Final Work Plan Addendum #1
for the Sampling of Soils Below Floor Slabs and Remediation at
RVAAP-08 Load Line 1 and Other Building Locations

Ravenna Army Ammunition Plant
8451 St. Route 5
Ravenna, OH 44266-9297

**DRAFT OF WORK PLAN ADDENDUM #1 FOR THE SAMPLING OF SOILS BELOW FLOOR SLABS AND
REMEDATION AT RVAAP-08 LOAD LINE 1 AND OTHER BUILDINGS
COMMENT RESPONSE TABLE
JULY 23, 2009**

URS					
RAVENNA ARMY AMMUNITION PLANT RAVENNA, OHIO					
SOIL SAMPLING UNDER FLOOR SLABS LOAD LINE 1 PLAN VIEW					
DRAWN BY: JSC	CHECKED BY: SL	PROJECT No: 13812319	DATE: 7/30/09	FIGURE No: 1-2	PAGE No: 1-3

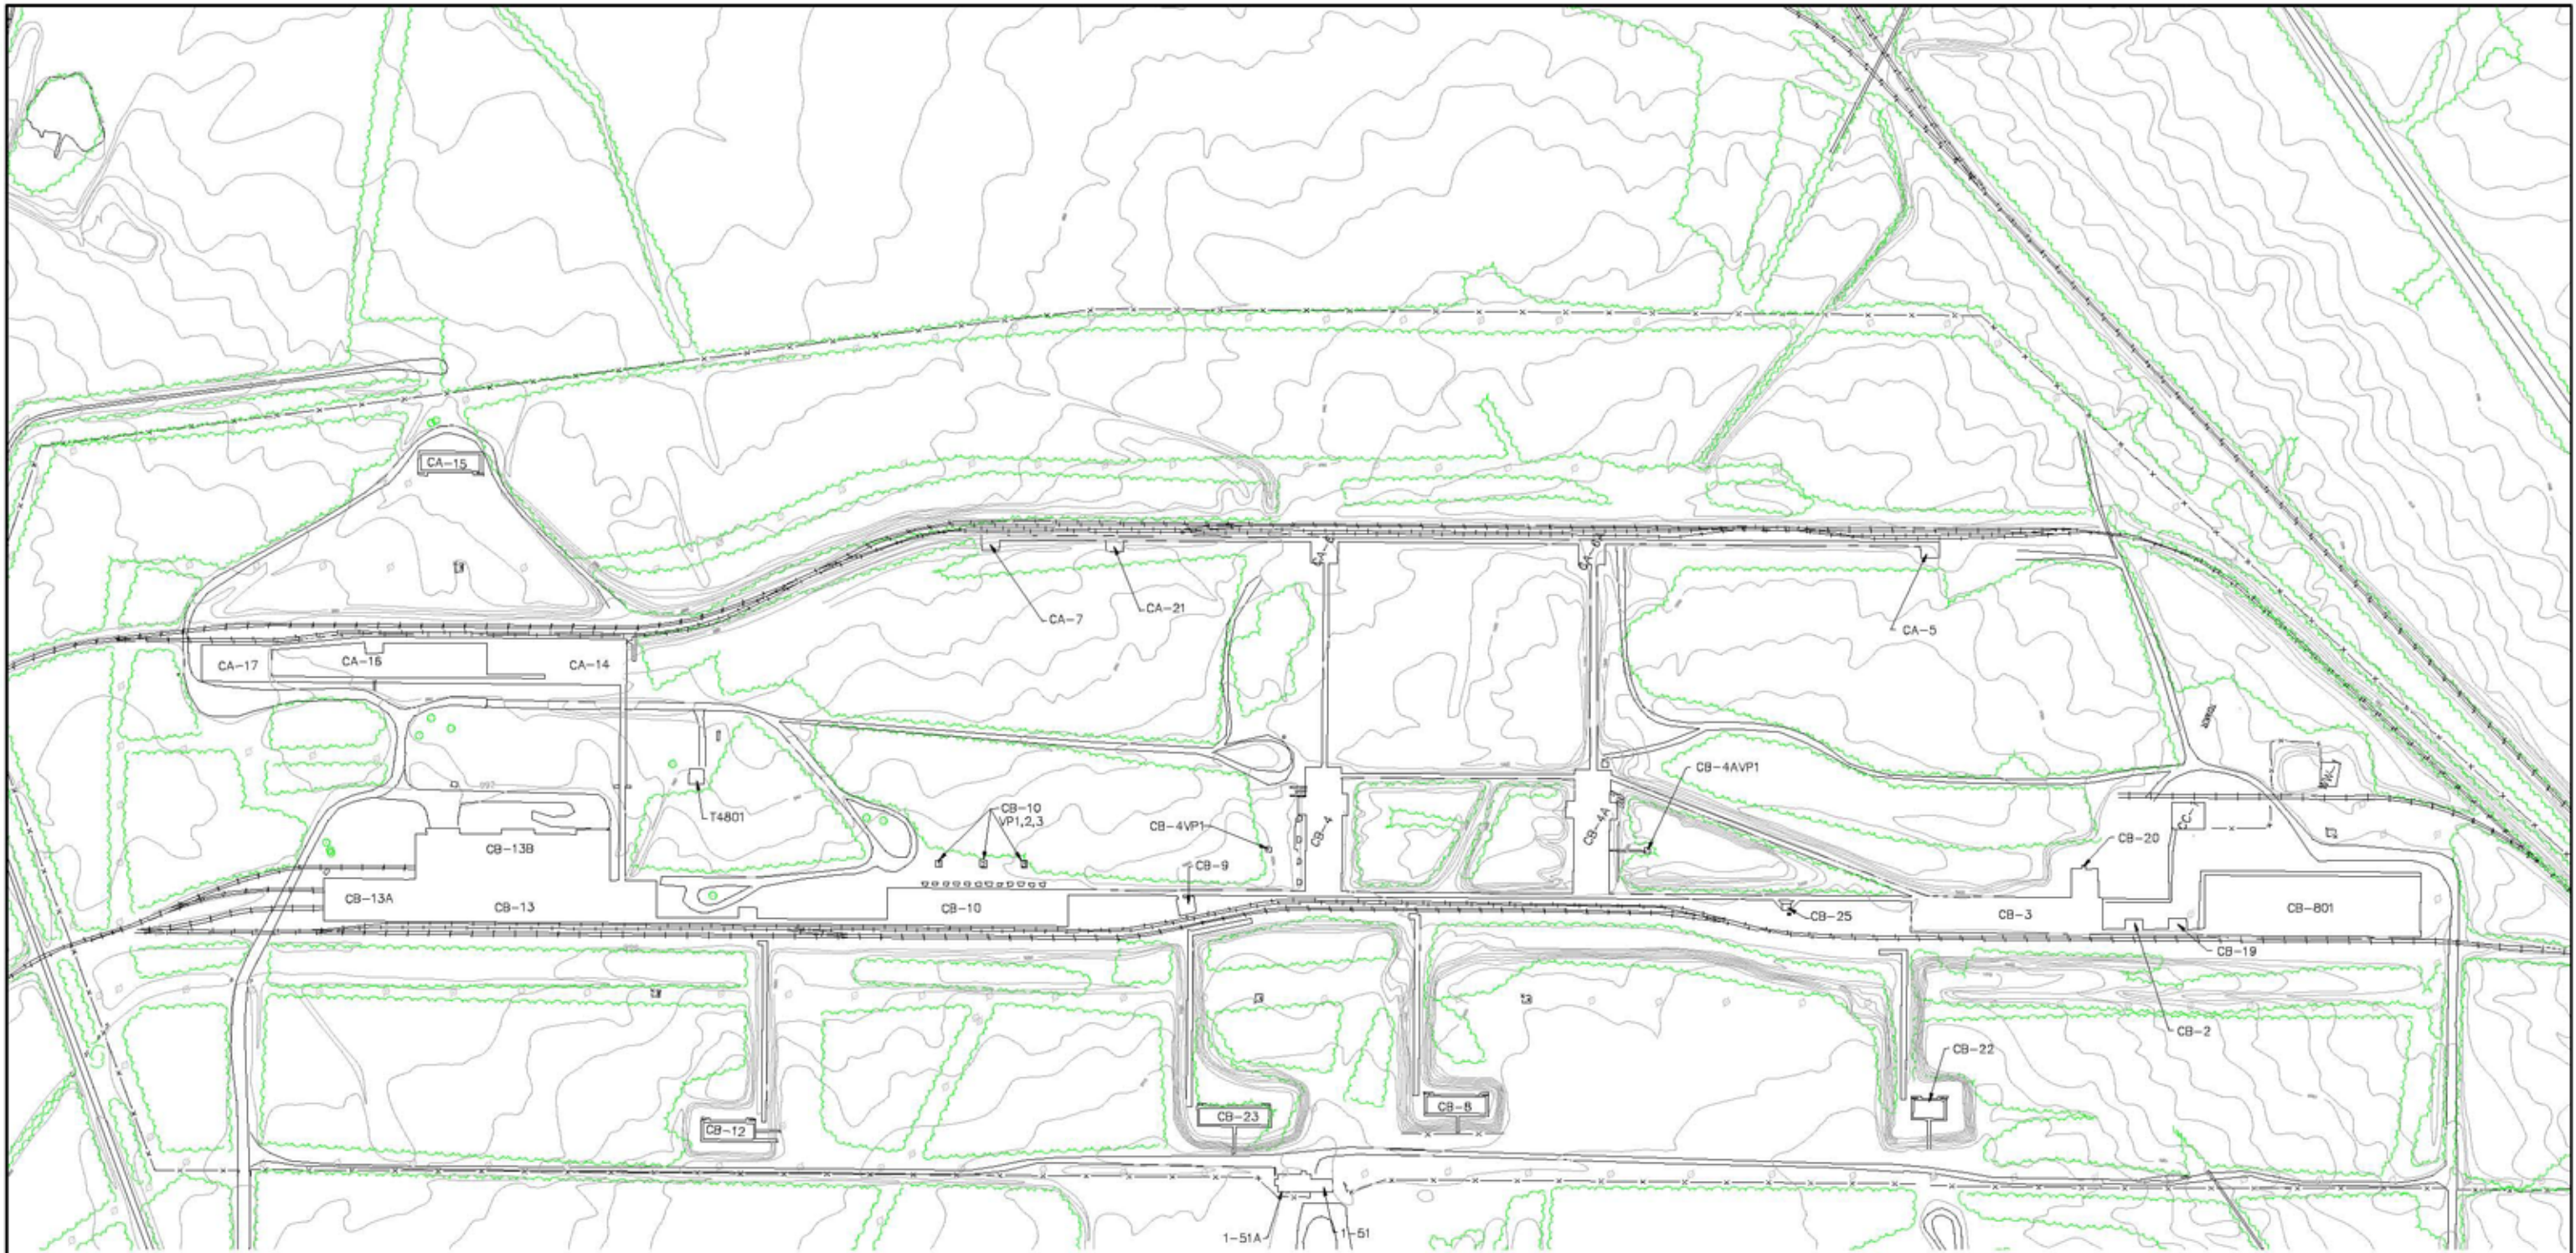
Comment Number	Page No./ Line No.	New Page or Sheet	Comment	Recommendation	Response
					<i>extent of sub-slab contamination was not fully delineated during the course of the RI.</i>
8	Fig 1-2		Revise figure.	<p>a. Add vacuum pump houses to the key (i.e., the circles with the numbers within).</p> <p>b. Add to the key what is meant by the very small circles with the dot inside.</p>	<p>Noted.</p> <p>a. - The circles with numbers designate the vacuum pump houses for bldg CB-10 and have been added to Figure 1-2.</p> <p>b. – The very small circles with the dot inside are a part of the original CAD file. These features have been identified as steam stanchions and have been so noted on the revised figure.</p>
9	2-1/4-7		Explanation required.	<p>The text indicates that the soil may still be transported to LL4 for temporary storage prior to disposal. Based on the fact that the designated buildings are to be removed, please clarify what conditions would need to be met in order to store materials here. Specifically, storage of material in these buildings should not impact the D/D schedule. There needs to be close coordination on this issue.</p>	<p>The intent of the text was to note that the original SOW specification to transport all excavated soils to the LL4 buildings had been changed. Since this is somewhat confusing the text has been changed as follows:</p> <p><i>The only substantive change is that soil determined to require removal will not be transported to Load Line 4 Buildings, but will, instead, be loaded, transported, and disposed at a licensed disposal facility in accordance with applicable state, federal, and local rules, laws, and regulations.</i></p>

URS					
RAVENNA ARMY AMMUNITION PLANT RAVENNA, OHIO					
SOIL SAMPLING UNDER FLOOR SLABS					
PROPOSED CORE LOCATIONS BUILDINGS CB-4 AND CB-4A					
DRAWN BY: JSC	CHECKED BY: SL	PROJECT No: 13812319	DATE: 7/30/09	FIGURE No: 3-2	PAGE No: 3-11

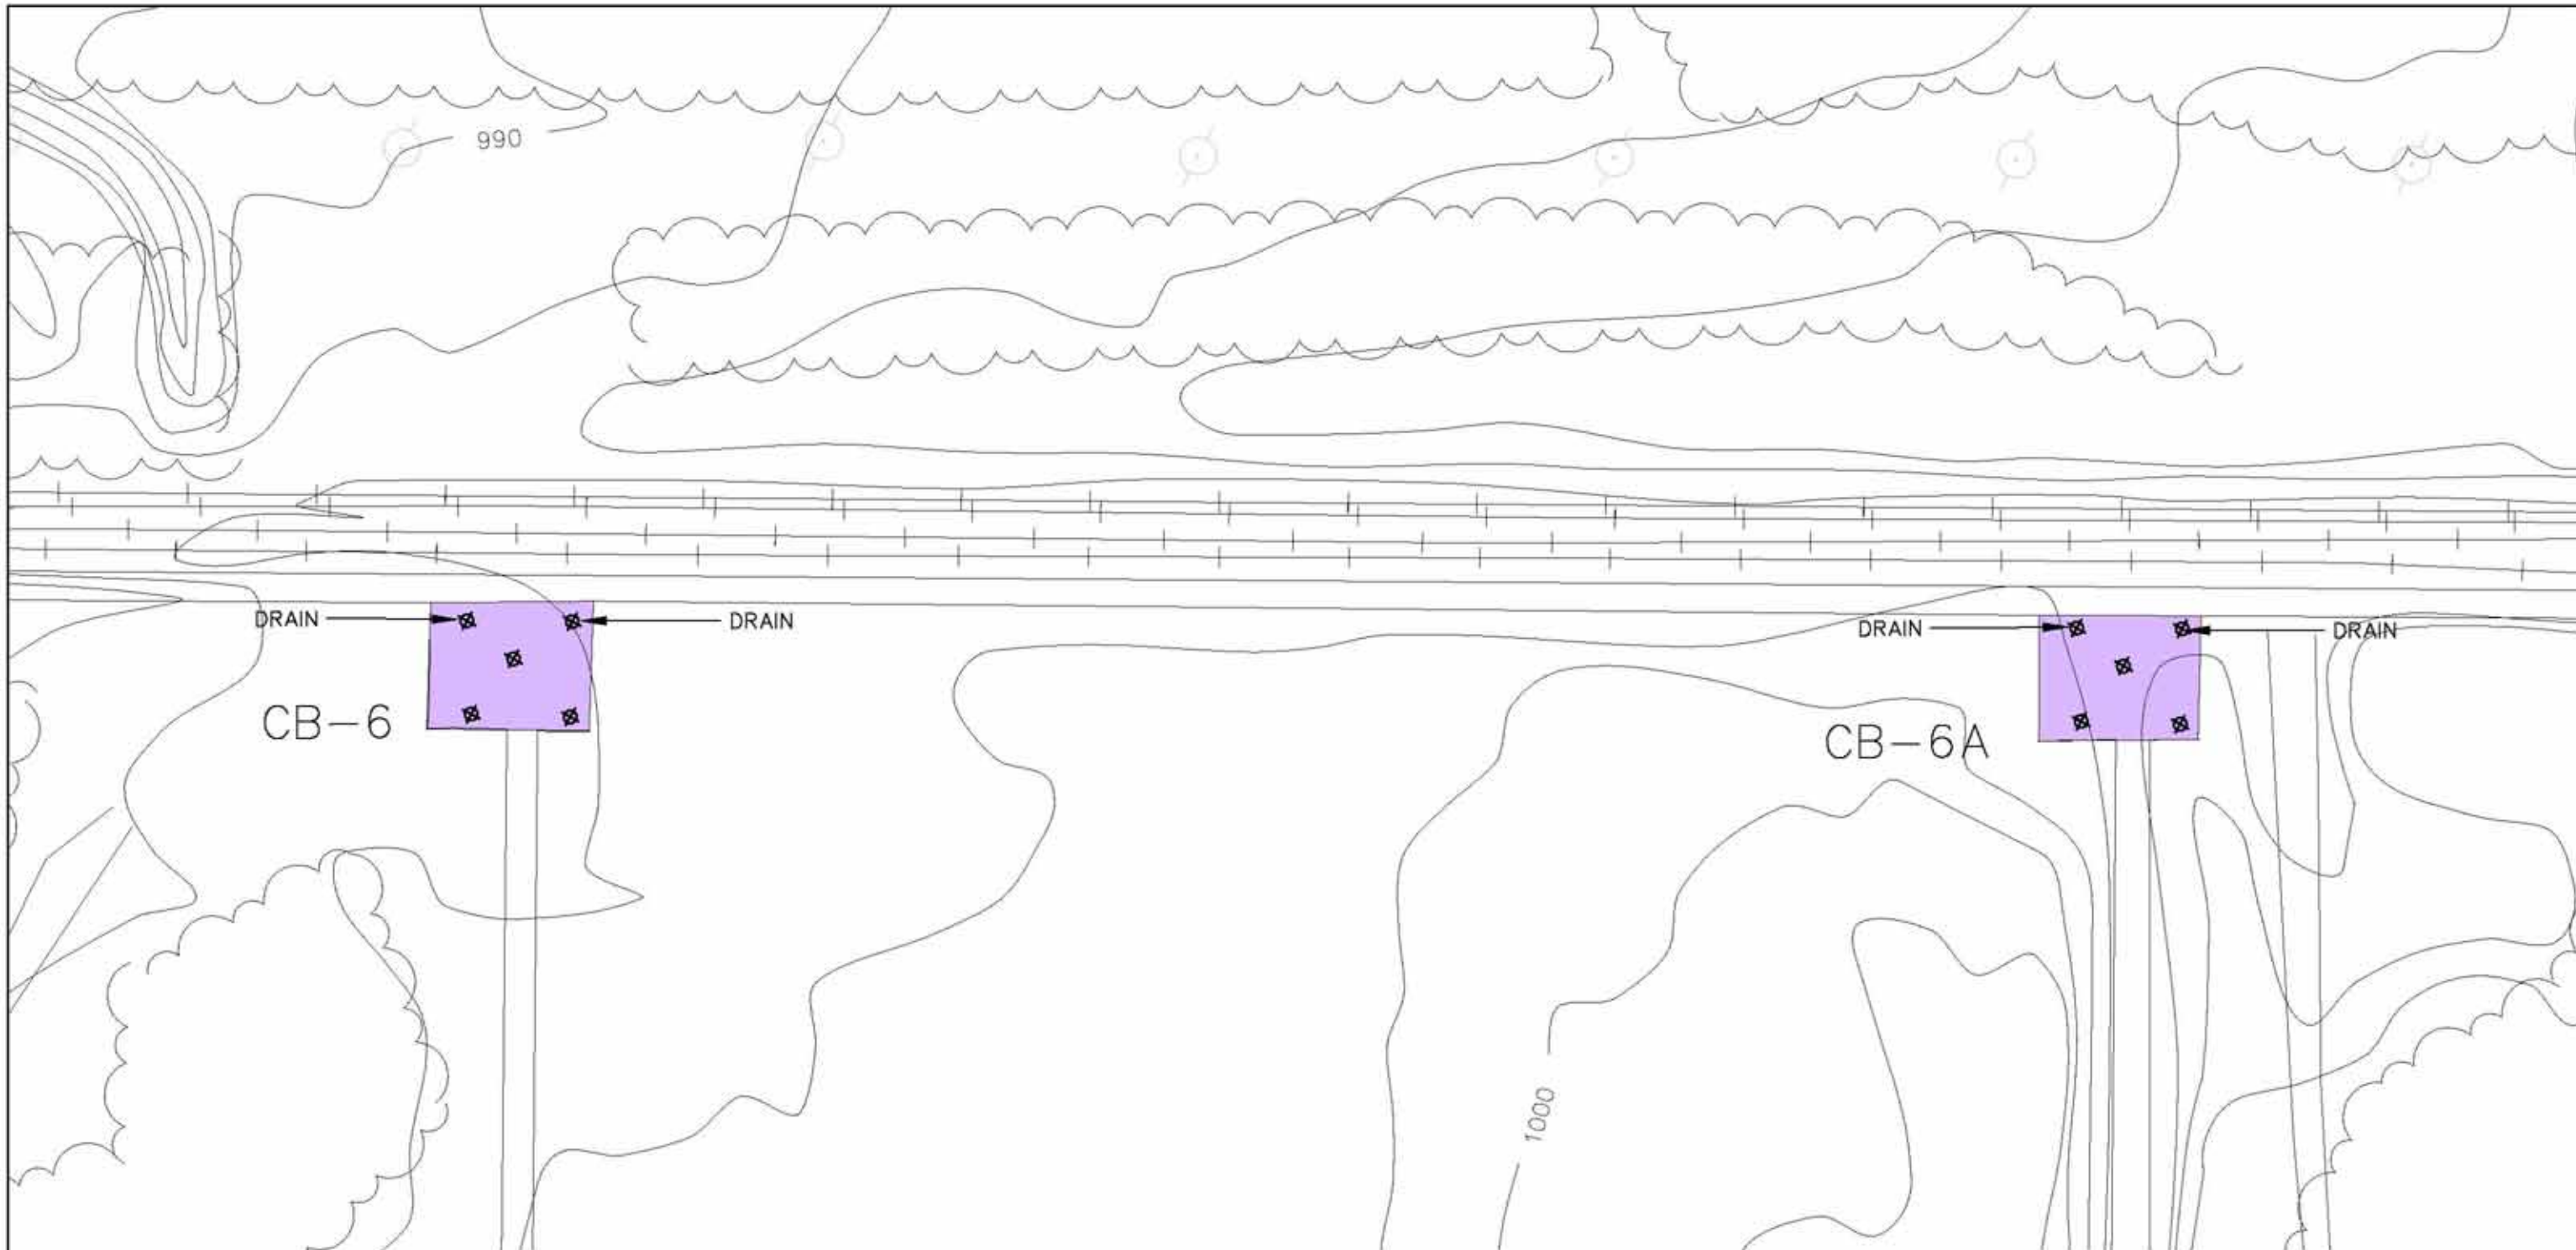
21	Figure 3-2		Revise figure.	<ul style="list-style-type: none"> a. Clarify if there are sumps at the wash-out annex. b. The RR tracks in the figure do not match the key. Revise to be consistent. c. Any apparent exit points to the vitreous clay tile? d. Add polygon shape to the key. 	<ul style="list-style-type: none"> a. Noted. The figures have been modified to indicate that sumps are present. b. Noted. The key has been revised to match the figure. c. None could be seen during the inspection. The drain appears to traverse behind the sump.

Comment Number	Page No./ Line No.	New Page or Sheet	Comment	Recommendation	Response
				<ul style="list-style-type: none"> e. Add square shape to the key. f. Add circle with “p” inside to the key. g. Add additional contour elevations to the figure. h. Add walkways to the key. i. What are the exit points for the external scupper drain holes? 	<ul style="list-style-type: none"> d. Noted. The polygon shape representing the vacuum unit enclosures has been added to the figure. e. Noted. The square shape representing small structures has been added to the key. f. Noted. The requested addition to the figure has been made. g. Available contour elevation values have been added to the figure. h. Noted. Walkways have been added to the figure key. i. This is a drain hole in the bldg slab to the sub slab soil. It is not clear if a drain was originally installed in the opening or the scupper materials were drained directly onto the ground surface.

URS				
RAVENNA ARMY AMMUNITION PLANT RAVENNA, OHIO				
SOIL SAMPLING UNDER FLOOR SLABS				
PROPOSED CORE LOCATIONS BUILDINGS CB-6, CB-6A				
DRAWN BY: JSC	CHECKED BY: SL	PROJECT No: 13812319	DATE: 7/30/09	FIGURE No: PAGE No: 3-3 3-12

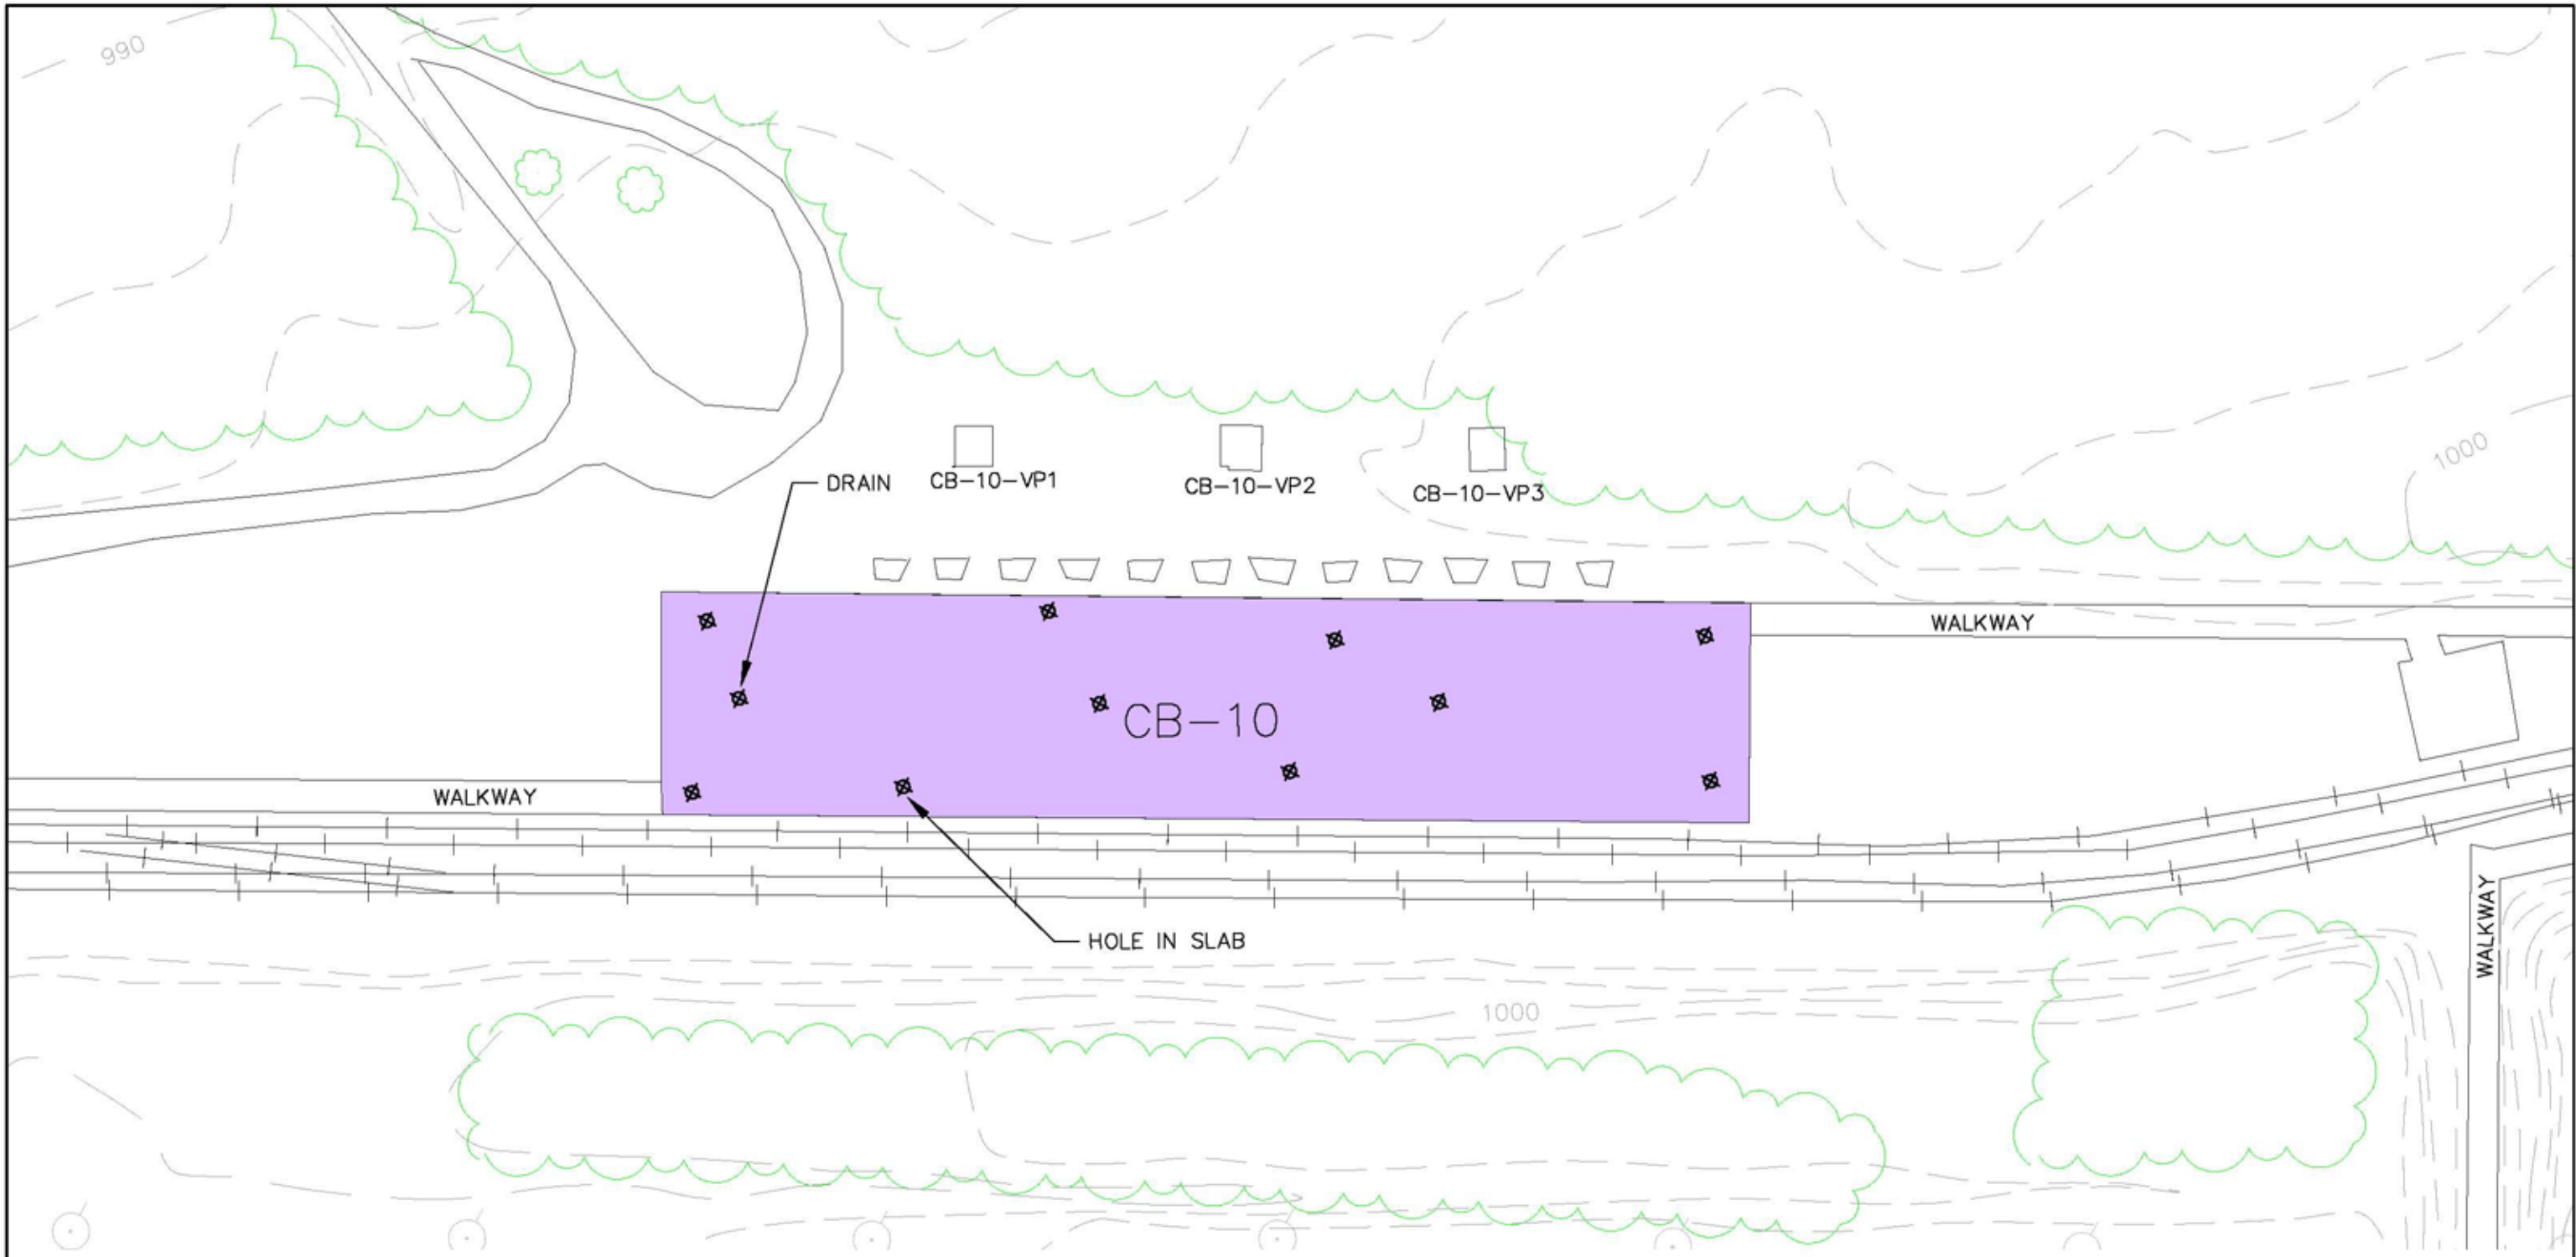
22	Figure 3-3		Revise figure.	<ul style="list-style-type: none"> a. Clarify the discharge points for the drains depicted on the figures. b. Add a few contour elevations to the figure. c. Add to the key what is meant by the circle with the dot inside and NE/SW trending line. d. The RR tracks in the figure do not match the key. Revise to be consistent. e. Add walkways to the key. 	<ul style="list-style-type: none"> a. Based upon the inspection it is not clear where the discharge points for these drains were located since the drain pipes have been removed from the drain. b. Available contour elevation values have been added to the figure. c. The circle with a dot and line are identified as steam stanchions. The figure legend has been modified to clarify.

Comment Number	Page No./ Line No.	New Page or Sheet	Comment	Recommendation	Response
					<p>d. Noted. The key has been revised to match the figure.</p> <p>e. Noted. Walkways have been added to the figure key.</p>
23	Figure 3-4		Revise figure.	<p>a. Clarify the discharge points for the drains depicted on the figures.</p> <p>b. Add polygon shape to the key.</p> <p>c. Add square shape to the key.</p> <p>d. Add large circle to the key.</p> <p>e. The RR tracks in the figure do not match the key. Revise to be consistent.</p> <p>f. Add to the key what is meant by the circle with the dot inside and NE trending line segment.</p> <p>g. Add a few contour elevations to the figure.</p> <p>h. Add walkways to the key.</p>	<p>a. The discharge points for the listed drain could not be ascertained during the inspection due to the demolition and removal of the drain pipes.</p> <p>b. Noted. The polygon shape representing the vacuum unit enclosures has been added to the figure.</p> <p>c. Noted. The square shape representing small structures has been added to the key.</p> <p>d. The large circles are the labels indicating the number assigned to the vacuum pump house (See Figure 1-2). These labels have been removed from Figure 3-4 and the VP buildings labeled appropriately.</p> <p>e. Noted. The key has been revised to match the figure.</p> <p>f. The circle with a dot and line are identified as steam stanchions in Figure 1-2. The figure legend will be modified to clarify.</p> <p>g. Available contour elevation values have been added to the figure.</p> <p>h. Walkways have been added to</p>
